APPLICATION NO.	FILING DATE	FIRST NAMED INVENTOR	ATTORNEY DOCKET NO.	CONFIRMATION NO.
10/820,080	04/06/2004	Paul Ciccone	SYNT-0237	7100
	7590 10/27/200 WASHBURN LLP		EXAMINER	
CIRA CENTRE	E, 12TH FLOOR		RAMANA, ANURADHA	
2929 ARCH STREET PHILADELPHIA, PA 19104-2891			ART UNIT	PAPER NUMBER
			3775	
			MAIL DATE	DELIVERY MODE
			10/27/2008	PAPER

Application No.	Applicant(s)				
	10/820,080	CICCONE ET AL.				
Office Action Summary	Examiner	Art Unit				
	Anu Ramana	3775				
The MAILING DATE of this communication app	ears on the cover sheet with the c	orrespondence address				
Period for Reply						
A SHORTENED STATUTORY PERIOD FOR REPLY WHICHEVER IS LONGER, FROM THE MAILING DA. - Extensions of time may be available under the provisions of 37 CFR 1.1: after SIX (6) MONTHS from the mailing date of this communication. - If NO period for reply is specified above, the maximum statutory period variety or period for reply within the set or extended period for reply will, by statute. Any reply received by the Office later than three months after the mailing earned patent term adjustment. See 37 CFR 1.704(b).	ATE OF THIS COMMUNICATION 36(a). In no event, however, may a reply be tin vill apply

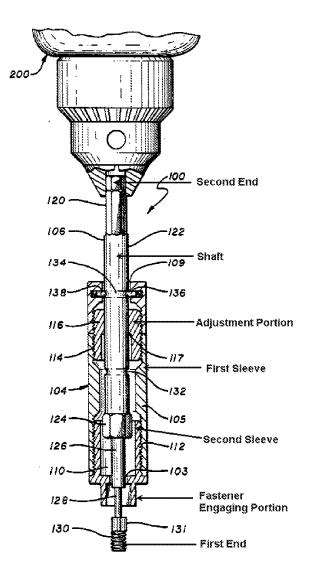
Lemke et al. disclose an adjustable tool including: a shaft (122, 116) with calibration markings (132, 134); a cutting portion 130, i.e. a portion capable of cutting into material; a fastener engaging portion 102; an adjustment portion 116; and an adjustment mechanism including a first sleeve 105 and a second sleeve 112 mounted on the shaft wherein the cutting portion and the fastener engaging portion can be rotated at different speeds with respect to one another (Figs. 4 and 5, col. 6, lines 47-68, col. 7 and col. 8, lines 1-2). See marked up Fig. 5 from Lemke et al. below.

The Lemke et al. device is fully capable of performing the stated function, "wherein when a cannulated fastener......distally beyond the fastener tip." It is the Examiner's position that if a suitably sized cannulated fastener is placed

on the fastener engaging portion 102, the distal cutting tip 130 is capable of extending distally beyond the fastener tip.
